STAFF RECOMMENDATION

2206 White Avenue

March 15, 2017

Application: New construction—infill and outbuilding

Figure 3. The side façade showing the house's depth.

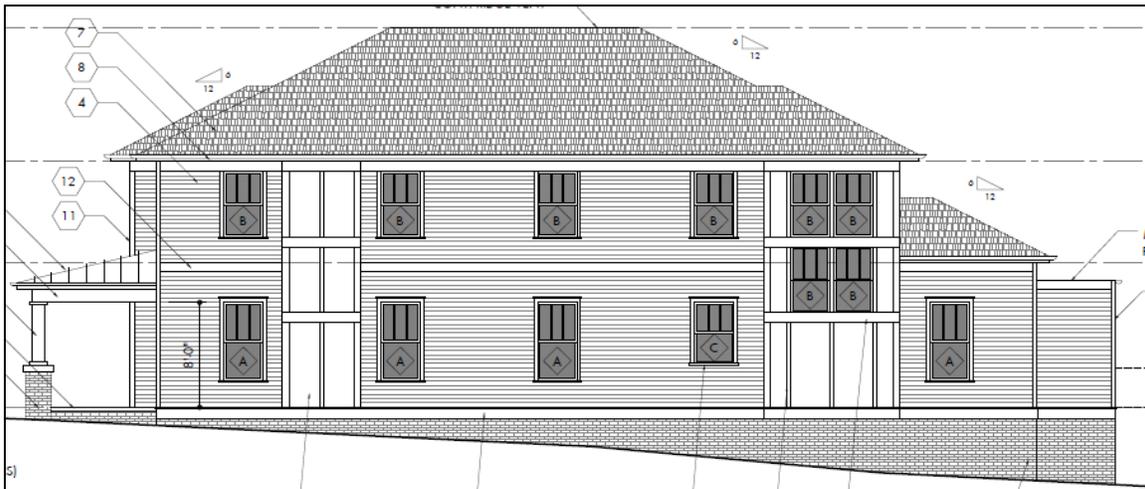
The house will have a total depth of eighty-one feet, four inches (81'4"), which includes an eight foot (8') deep front porch (Figure 3). The main two-story portion of the house will be fifty-six feet, four inches (56'4") deep, which helps to keep the scale of the house appropriate. By comparison, the historic houses on the block have depths between fifty-three and fifty-eight feet (53'-58'). The two story house at 2223 White Avenue has a depth of fifty-three feet (53') (see Figure 2).

A1.00

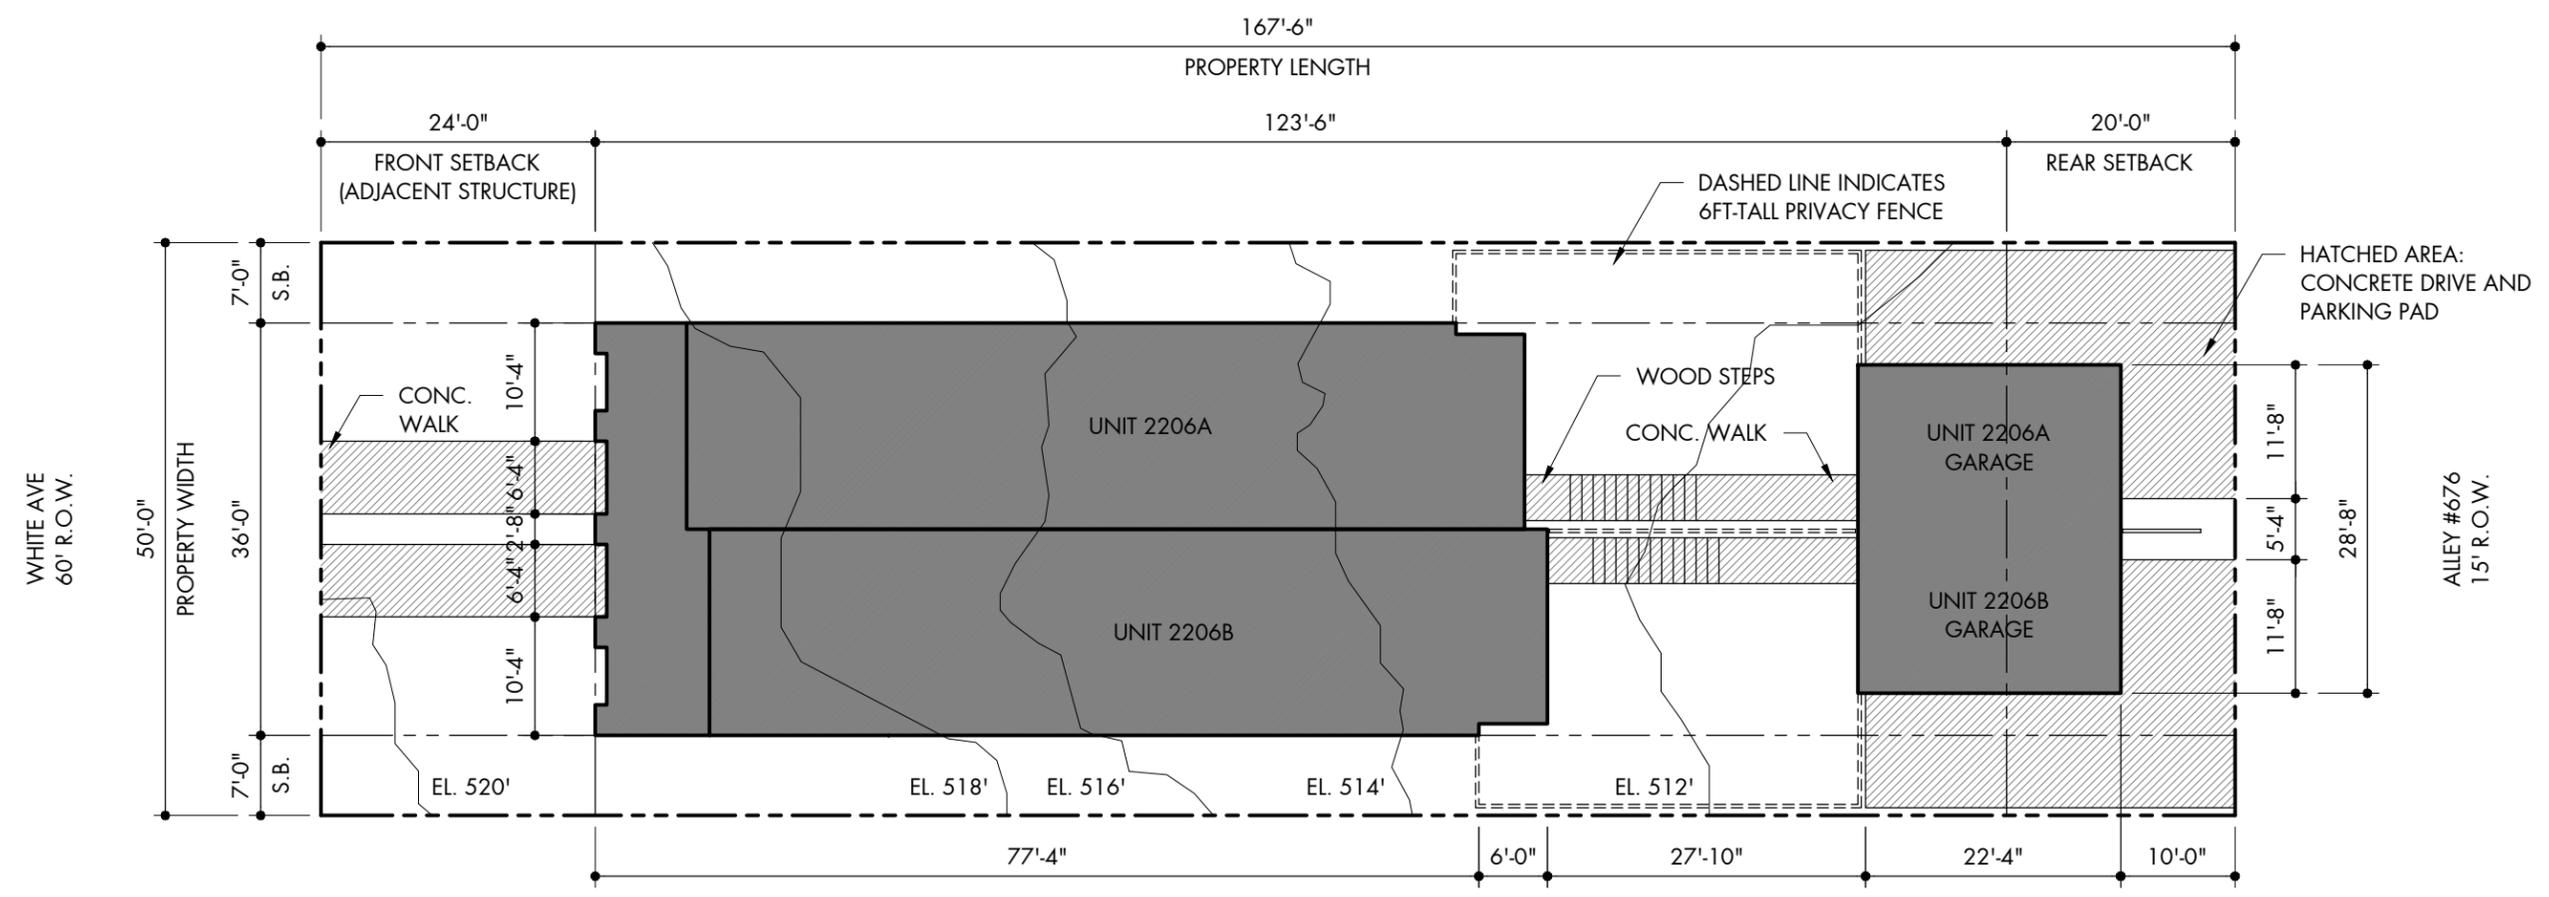
Setback & Rhythm of Spacing: The proposed infill meets all base zoning setbacks. It will be seven feet (7') from each of the side property lines, and sixty feet (60') from the rear property line. Its front façade will be twenty-four feet (24') back from the front property line to line up with the historic house next door at 2208 White Avenue. Staff recommends that the site plan include the front setbacks of the two adjacent houses.

9. The site plan include the front setbacks of the adjacent houses;
10. The finished floor height be consistent with the finished floor heights of the adjacent historic houses, to be verified by MHZC staff in the field;
11. Staff approve masonry samples;
12. Staff approve all windows and doors prior to purchase and installation;
13. Staff approve the color and texture of the shingle roof and the metal roof;
14. Staff approve the design, material, and location of all fencing;
15. The outbuilding's siding have a maximum reveal of five inches (5"); and
16. The HVAC units be located behind the house or on either side, beyond the mid-point of the house.

A2.05

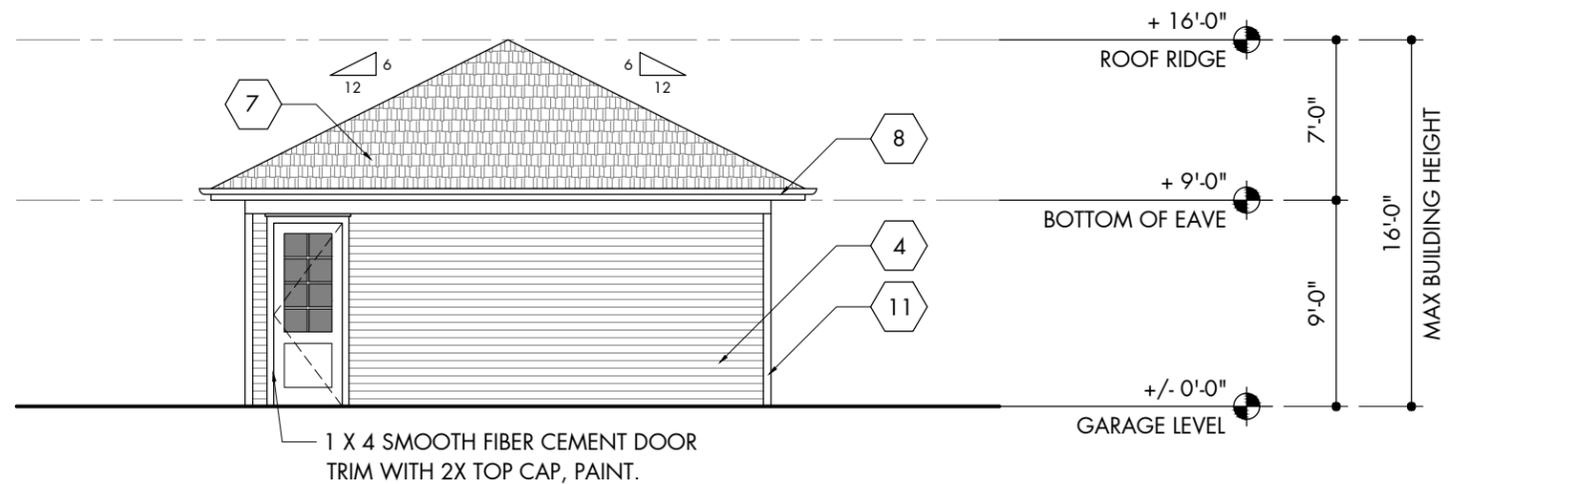
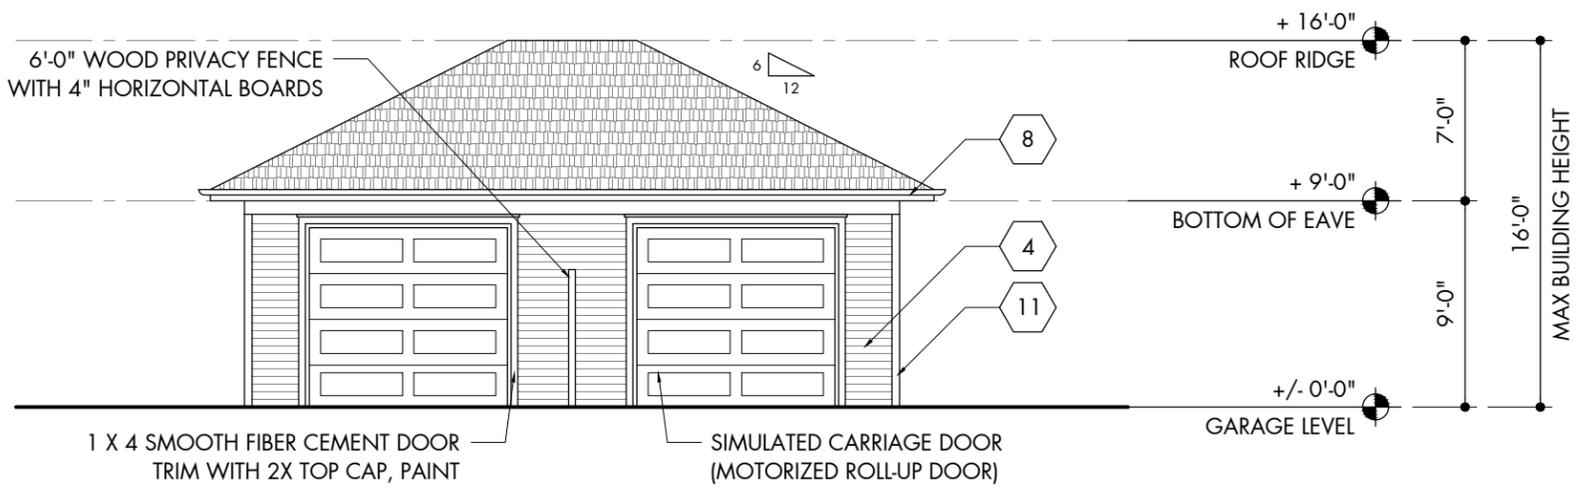
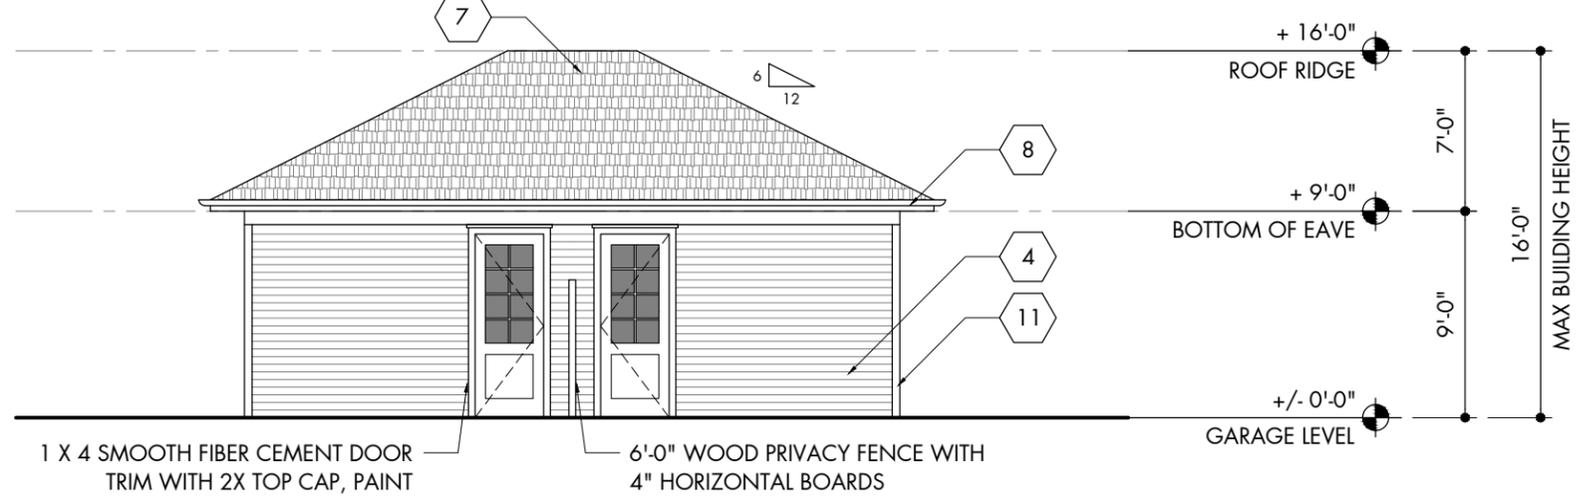
* The design guidelines state that lap siding shall have a maximum reveal of five inches (5"), even for outbuildings. Staff recommends that the lap siding for the garage have a maximum reveal of five inches (5"). With this condition, and the staff's final approval of the doors, staff finds that the known materials meet Section III.B.2.h. of the design guidelines.
